Access Compliance Report Public Rights-of-Way (Curb Ramps)

Intersection ID: 10021320	Main Street: BLAKENEY GREENS BV	Cross Street: N/A	Location: NW
ADA ID: AF4A69897625	Ramp Type: PerpDiag	Initial Pass/Fail: Fail	Overall Compliance: No Severity Score: 25

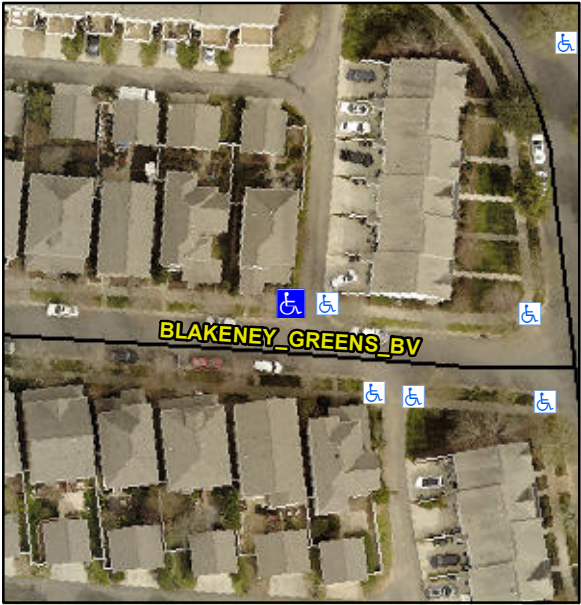
Compliance	Description	Data	Compliance	Description	Data
N/A	Ramp Length (in)	51.0	No	Ramp Slope (%)	14.9
Yes	Ramp Width (in)	48.0	Yes	Ramp XSlope (%)	1.9
N/A	Flare Type LT	N/A	N/A	Flare Type RT	N/A
N/A	Flare Slope LT (%)	N/A	N/A	Flare Slope RT (%)	N/A
N/A	Flare Traversable LT?	N/A	N/A	Flare Traversable RT?	N/A
N/A	Landing Length (in)	N/A	N/A	DWS Provided?	N/A
N/A	Landing Width (in)	N/A	N/A	DWS Contrast?	N/A
N/A	Landing Slope (%)	N/A	N/A	DWS Length (in)	N/A
N/A	Landing X Slope (%)	N/A	N/A	DWS Full Width?	N/A
N/A	Landing Curb? (Y/N)	N/A	N/A	DWS Offset (in)	N/A
N/A	Shared Landing?	N/A			
N/A	Gutter Ponding?	N/A	N/A	Gutter Slope (%)	N/A
N/A	Gutter Lip Ht (in)	N/A	N/A	Gutter X Slope (%)	N/A
N/A	Painted X Walk1?	No	N/A	Painted X Walk2?	No
	X Walk 1 Direction	To S		X Walk 2 Direction	To SE
N/A	X Walk 1 Width (in)	N/A	N/A	X Walk 2 Width (in)	N/A
	X Walk 1 Slope (%)	3.0		X Walk 2 Slope (%)	0.7
	X Walk 1 X Slope (%)	0.2		X Walk 2 X Slope (%)	4.5

N/A	Ramp inside XWalk1?	N/A	N/A	Ramp inside XWalk2?	N/A
	Road Slope (%)	4.3	N/A	Clear Space?	N/A
	Road X Slope (%)	0.2	N/A	Clear Space to XWalk (in)	N/A
N/A	Any Obstructions?	N/A	N/A	Storm Grate/Utility Hazard?	N/A
	Obstruction Type			Storm Grate/Utility Type	
		N/A			N/A
			Yes	Surface Condition? (G/P)	Good

Possible Solutions:
Remove & Replace Curb Ramp With Two New Directional Ramps or Equivalent.
